APPLICATION NO.	FILING DATE	FIRST NAMED INVENTOR	ATTORNEY DOCKET NO.	CONFIRMATION NO.
10/783,162	02/20/2004	Wade D. Vinson	200400249-1	7167

Office Action Summary	Application No. 10/783,162	Applicant(s) VINSON ET AL.	
	Examiner VIKANSHA S. DWIVEDI	Art Unit 3741

DETAILED ACTION

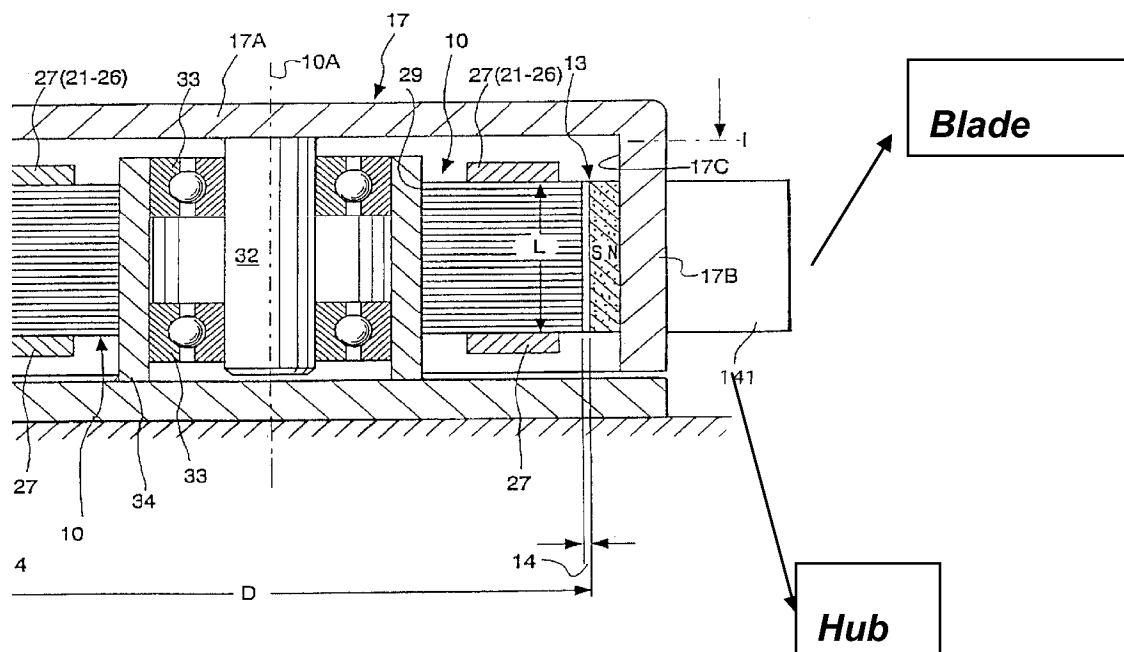
Von der Heide teaches a cooling fan comprising: a three-phase DC motor, an impeller comprising a hub to house said motor and a plurality of blades 141 extending from the hub. It should be clear rotor housing 17 is the hub and has plurality of blades 139 and 141 extending from the hub 17. for applicant's convenience the hub and the Blade are shown below. It is a marked up copy of Von der Heide figure 2.

It should be clear that a impeller is the rotating part that transmits motion in a device such as a cooling fan. In case of Von der Heide a magnetic external rotor comprises an inverted cup-shaped rotor housing/hub 17 with a horizontal top surface 17A and a cylindrical circumferential wall 17B that supports the blades 139 and 141. Stub shaft 32 is attached to the center of rotor housing 17 at the center of top 17A. Stub shaft 32 rides in ball bearing journals 33 and is supported thereby in a manner that rotor housing 17 is pivotally secured to stator 10 and can rotate about center axis 10A. Von der is silent about the blades being at least 25 % of the impeller diameter. At the time of invention it would have been obvious to one of ordinary skill in the art at the time of invention to modify Von der Heide in view of Leupold to increase the durability of the arrangement (col. 1 ll. 55-60). Von der Heide in view of Leupold does not teach a rare earth magnet. Leupold teaches a rare earth magnet. At the time of invention it would have been obvious to one of ordinary skill in the art at the time of invention to modify Von der Heide in view of Leupold to produce optimal magnetic fields in electric machinery (Background of Invention).
